7VE6 problem with default and control display with French language setting

Faulty default and control display after change of the device language from English to French.
Device 7VE6, FW V4.61.01, P-Set V4.61.01 (Delivered until Digsig V4.88 installation)

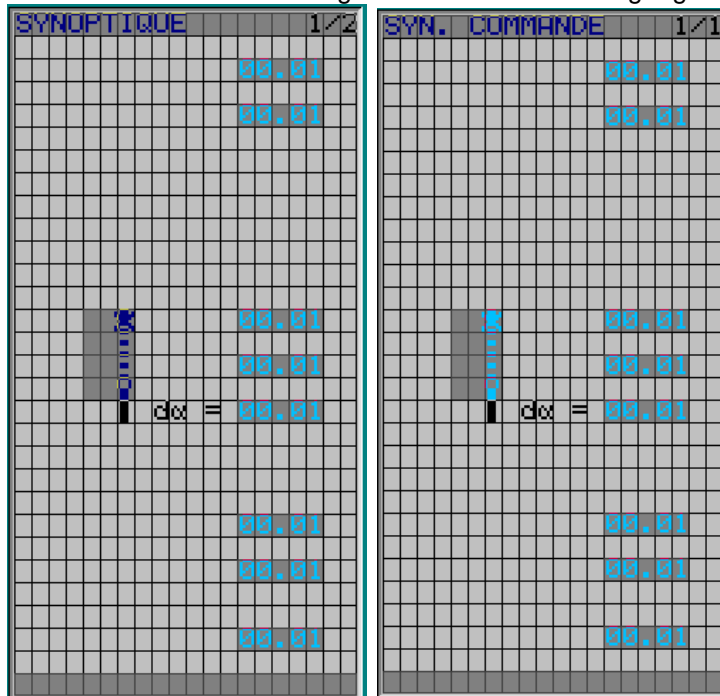
1. English device language -> default and control display correct

2. after change to french device language

-> missing symbols after the changing the language.

Remark: if there is one change EN to DE or other languages the problem does not appear.

One new Digi parameter-set with corrected French textpool is available in the download pool www.siprotec.com/protection

7VE6xx_V046101_GerTreiDig0480_V01.00.06.exe (without help) und
7VE6xx_V046101_GerTreiDig0480_V01.01.06.exe (with help)

1. installation of the parameter-set in Digi
2. open the existent dex.-file with the faulty display offline.
3. change the language FR -> EN and save.
4. change the language FR -> EN and save
5. open the default and control display and check if it is correct now.
6. initialize the device and check the default and control display of the relay
7. In case that the display is still indicated incorrect please load the device firmware once again and initialize the device once.
